We have read your comments carefully and have made revision. We have tried our best to revise our manuscript according to the comments: "Application of Wave-current coupled Sediment Transport Models with Variable Grain Properties for Coastal Morphodynamics: A Case Study of the Changhua River, Hainan (egosphere-2024-2154)".

Here is a point-by-point response to the comments and concerns (42 comments.).

Figure 7: Comparison of maximum wave height and peak wave period calculated with the calibrated model against the field measured (Adapted from the study by Wang (2023)).

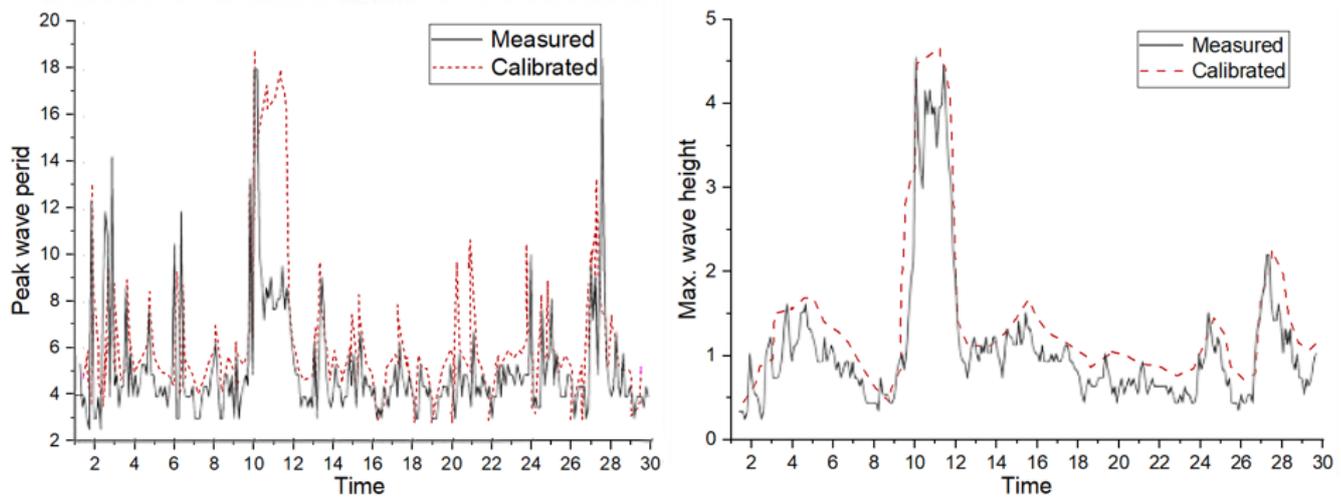
Comment: Firstly, I have not found a proper response to referee 1 point 6 about validating model currents and waves other than tides. Indeed (lines 294-295) “substantial agreement . . . particularly in regions where tidal currents are predominant” suggests that other currents (e.g. due to winds) are not so well modelled and there is nothing about waves.

In response to the comments, we would like to clarify that our hydrodynamic model does incorporate wind fields as a driving force, and the sea current validation is based on in situ ADCP velocity and direction measurements. But there is something wrong with the statement in lines 294 to 295, and I have deleted this sentence. To further address the referee's concern about the validation of waves, we have included wave validation using empirical wave data from the Dongfang Wave Station for November 2013, as presented in Wang (2023) paper. This data includes maximum wave height and peak wave period, which are crucial parameters for assessing the model's performance in simulating wave dynamics.

“To substantiate the accuracy of our hydrodynamic model, we incorporated wave validation using comprehensive wave data from Wang (2023), which includes the maximum wave height and peak wave period observed throughout November 2013. The wave validation results are depicted in Fig. 7. The figure illustrates a substantial agreement between the modeled and observed wave parameters, affirming the reliability of our model in reproducing wave conditions. The agreement between the model's wave predictions and the empirical data underscores the robustness of our wave model.”

Figure 3: Location of sediment sampling point in the channel (map origination: <https://hainan.tianditu.gov.cn/>)

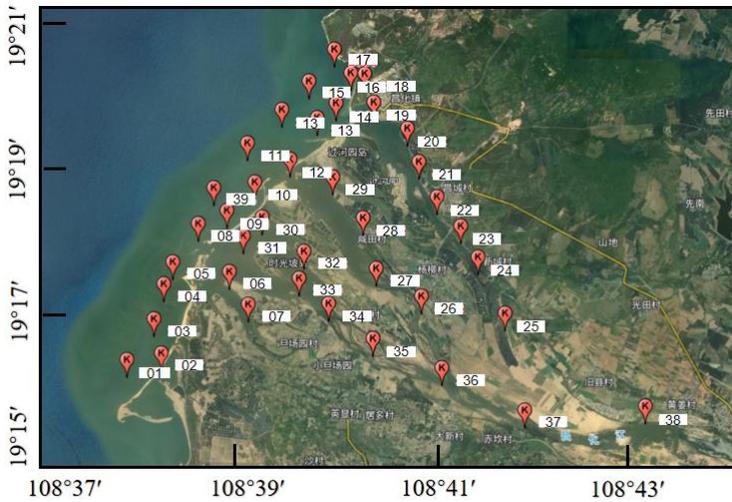
Point 8: Figure 3 and Tables 2, 3. The location labels in figure 3 are very hard to read. If you think the tables are useful then you need to relate each table row to a location in Figure 3. Similarly, the sample numbers in Figure 4 should be related to locations in Figure 3.

Figure 3 Revision: We have enhanced the readability of the location labels in Figure 3. The points now correspond clearly with those in Figure 4, ensuring that the visual representation is both clear and directly related to the sampling data.

Streamlining of Tables: After careful consideration of your comments on the usefulness of Tables 2 and 3, we have decided to remove these tables due to their redundancy and the potential for confusion. Instead, we will retain Table 4, which succinctly represents the sampling points' information in a clear and concise manner. This table will be directly related to the locations indicated in Figure 3, ensuring that the connection between the visual data and

Figure 6: (a) Scope of study area (the white frame) and wave observation (the red star) from Dongfang; (b) The track of the survey vessel equipped with the ADCP; (c) Grids and boundaries (map origination: <https://hainan.tianditu.gov.cn/>)

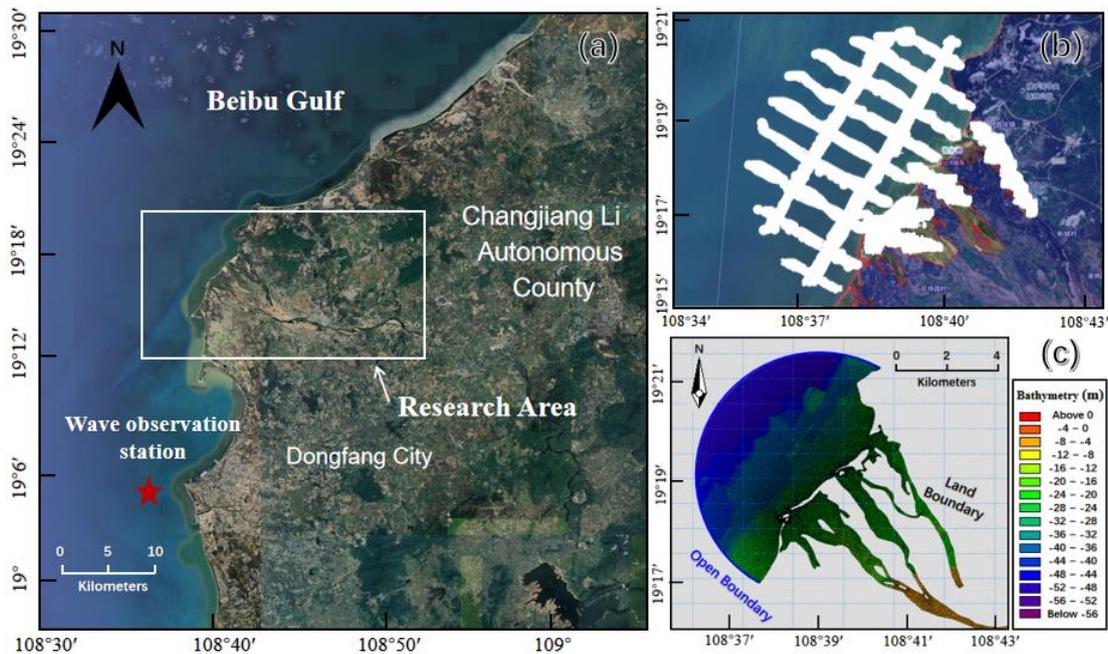
Point 12: Line 227. “ADCP collection points” are very unclear in Figure 6(b). Better to refer to Figure 8?

Upon reviewing the figures and the associated text, we have noted that Figure 6(b) indeed displays the points where bathymetric data was collected using a shipboard ADCP, which is distinct from the current velocity and direction measurements depicted in Figure 8. These two figures serve different purposes in our study: Figure 6(b) illustrates the spatial coverage of our bathymetric surveys, which are crucial for understanding the underwater topography and its influence on flow patterns, while Figure 8 shows the specific locations where current velocity and direction were measured to validate our hydrodynamic model.

We have revised Figure 6(b) to now display the track of the survey vessel equipped with the ADCP. This change addresses the issue of cluttered points and overlapping labels by providing a visual representation of the vessel's path, which allows for a clearer depiction of the data collection route rather than individual points.

Figure 17: Current speed on April 23rd

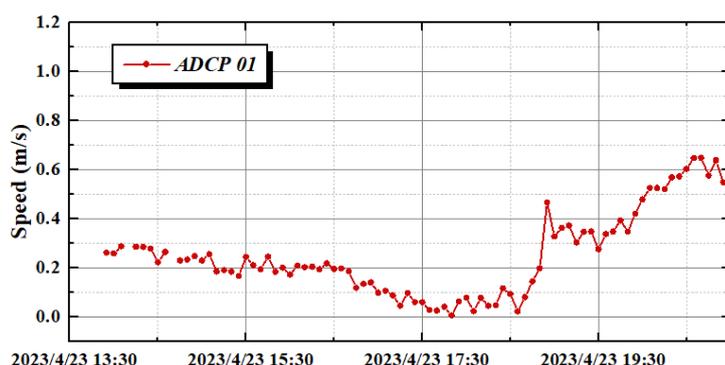
Point 24: Lines 426-427. I think you should refer to figure 16. Figure 16 needs hours on the time axis; the same date at four times is not useful.

We understand your concern about the presentation of time data on the time axis of Figure 16. To address this, we have revised Figure 16 to include hours on the time axis, which will provide a more detailed and useful representation of the data over time. This change will allow readers

The revised figure now includes a time axis with specific hours, which will replace the previous format that showed the same date at four different times. This improvement will enhance the readability and interpretability of the figure, ensuring that the data aligns with the temporal resolution necessary for the analysis.

We have also updated the text in lines 426-427 to reflect these changes and to guide the reader to the revised Figure 16, which now accurately represents the sediment deposition characteristics at the specified times.

“on April 23rd from 13:30 to 20:30, coincided with astronomical mid-tide but exhibited lower current velocities than expected, as per ADCP 01 measurements (Figure 17).”
